Product Change Notification

■Product List MQC-18-001_Embossed Packaging Specification Change

【Attachment 2】 Changes

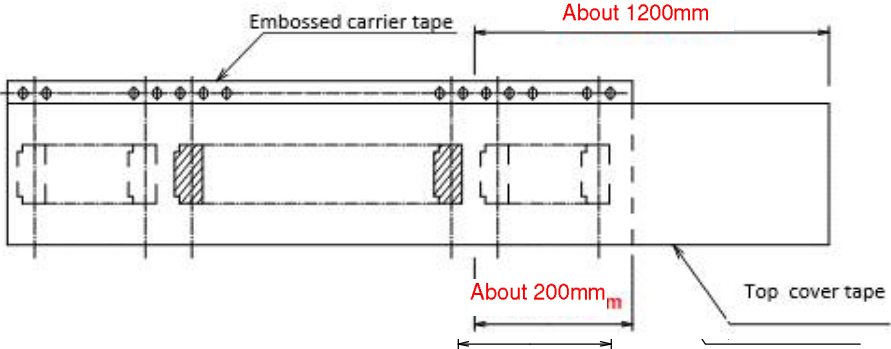
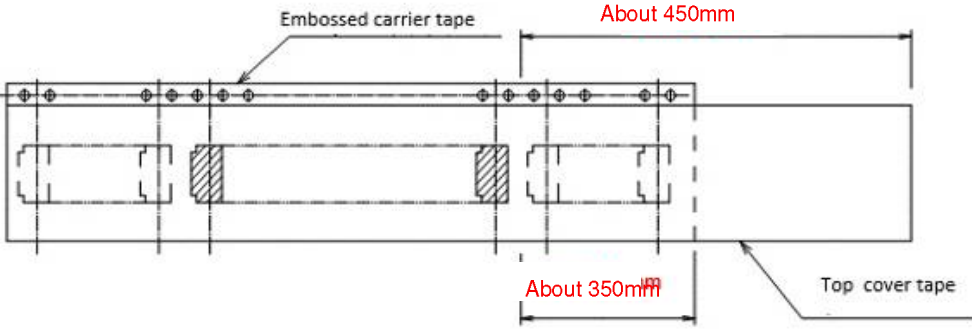
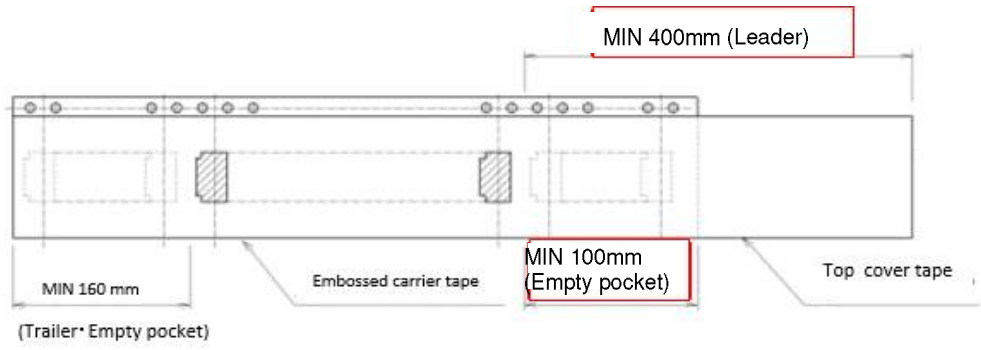
Before changes	
After changes	
Catalogue drawing

(Reference) IEC 60286-3(JIS C 0806)
